Intersection ID: 17409	Main Street: HILLSIDE_AV	Cross Street: PARK_RD	Location:	NE
ADA ID: 8E28DFDF189F	Ramp Type: BlendTrans2	Initial Pass/Fail: Fail	Overall Compliance: No	Severity Score: 36.25

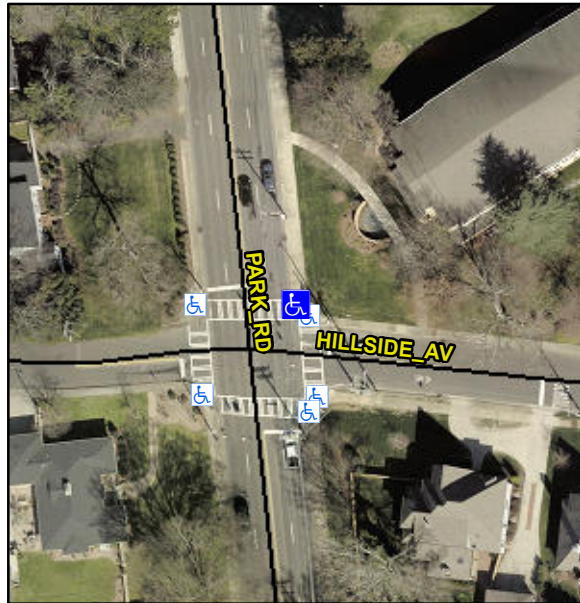
Possible Solutions:			Compliance	Description	Data	Compliance	Description	Data
Remove & Replace Curb Ramp With Two New Directional Ramps or Equivalent.	N/A	Ramp Length (in)	96.0	Yes	BlendTrans Slope (%)	2.4		
	No	Ramp Width (in)	25.0	No	BlendTrans XSlope (%)	4.7		
	N/A	Flare Type LT	N/A	N/A	Flare Type RT	N/A		
	N/A	Flare Slope LT (%)	N/A	N/A	Flare Slope RT (%)	N/A		
	N/A	Flare Traversable LT?	N/A	N/A	Flare Traversable RT?	N/A		
	N/A	Landing Length (in)	N/A	N/A	DWS Provided?	N/A		
	N/A	Landing Width (in)	N/A	N/A	DWS Contrast?	N/A		
	N/A	Landing Slope (%)	N/A	N/A	DWS Length (in)	N/A		
	N/A	Landing X Slope (%)	N/A	N/A	DWS Full Width?	N/A		
	N/A	Landing Curb? (Y/N)	N/A	N/A	DWS Offset (in)	N/A		
	N/A	Shared Landing?	N/A					
	Surveyor Notes: N/A	N/A	Gutter Ponding?	N/A	N/A	Gutter Slope (%)	N/A	
N/A		Gutter Lip Ht (in)	N/A	N/A	Gutter X Slope (%)	N/A		
N/A		Painted X Walk1?	Yes	N/A	Painted X Walk2?	N/A		
		X Walk 1 Direction	To W		X Walk 2 Direction	N/A

X Walk 1 Width (in)	114.0		X Walk 2 Width (in)	N/A		
		X Walk 1 Slope (%)	7.3		X Walk 2 Slope (%)	N/A		
		X Walk 1 X Slope (%)	1.0		X Walk 2 X Slope (%)	N/A		
N/A		Ramp inside XWalk1?	Yes	N/A	Ramp inside XWalk2?	N/A		
		Road Slope (%)	1.0		Clear Space?	N/A		
		Road X Slope (%)	7.3	N/A	Clear Space to XWalk (in)	N/A		
N/A		Any Obstructions?	N/A	N/A	Storm Grate/Utility Hazard?	N/A		
PROW/ADA: R304.5.1, R304.5.3			Obstruction Type			Storm Grate/Utility Type		
			N/A			N/A		
				Yes	Surface Condition? (G/P)	Good		
Total Cost:	\$	3200.00		N/A	Curb Slope (%)	0.7

Remove & Replace Curb Ramp With Two New Directional Ramps or Equivalent.
